# Conditions of Approval

## Prior to Release Requirements

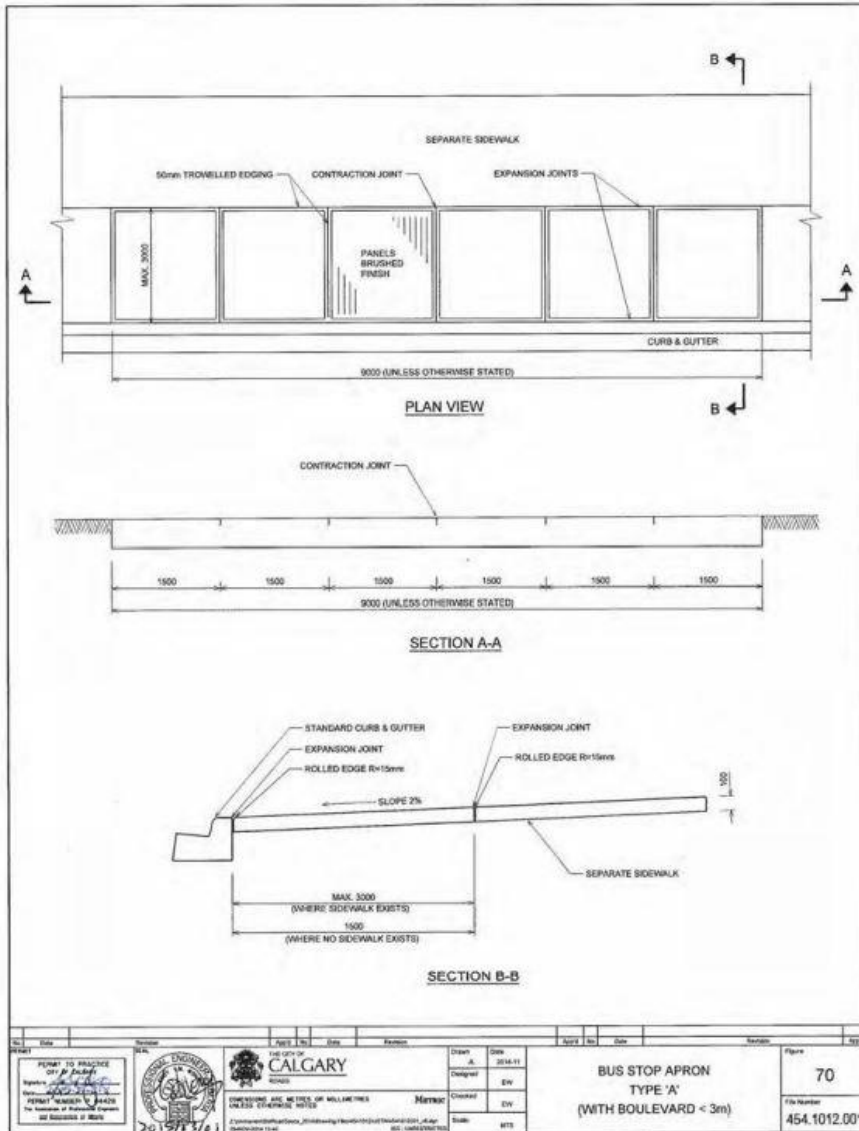
28. Applicant is to provide a new Type A bus pad (See image below) to be constructed at Eastbound 12 Avenue S.E. nearside of Olympic Way S.E., to allow for the relocation of the stop from its current farside location.

Ensure the 12 Ave S.E. Eastbound curbside lane East of Olympic Way is aligned with Eastbound 12 Avenue S.E. Eastbound curbside lane West of Olympic Way S.E. to allow Transit through-movement. Amend all plans accordingly.
